Our ref: SSD-45024776 | Narwee Parklands Seniors Housing

Subject: Request for Additional Information

Figure 2: Required cross sections demonstrated by green arrows.

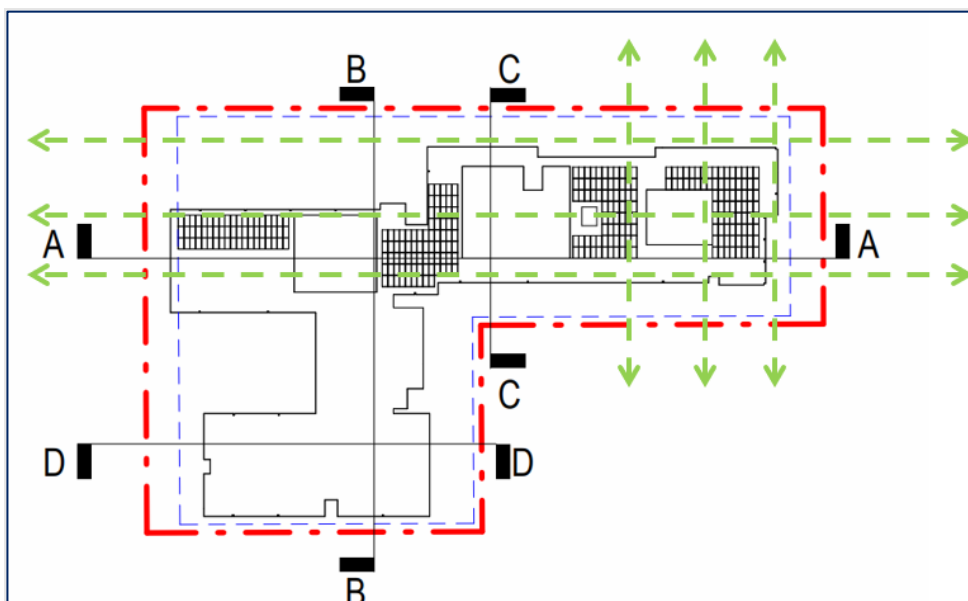
- (a) Architectural Plans
 - (i) Revised Gross Floor Area (GFA)/Floor Space Ratio (FSR) diagrams are to be submitted that include the various sheds located across the site. The proposal is to strictly comply with the FSR development standard.
 - (ii) Elevations and sections must be revised to reference the existing ground level.
 - (iii) RL's are to be provided on all elevations, sections and floor plans for all areas of the roof, mechanical plant, lift overrun and retaining walls.
 - (iv) Allocation of RCF and staff car parking spaces are to be identified on the plans.
 - (v) Detailed cross sections are required to be submitted for the sections identified with green arrows in **Figure 2** below.
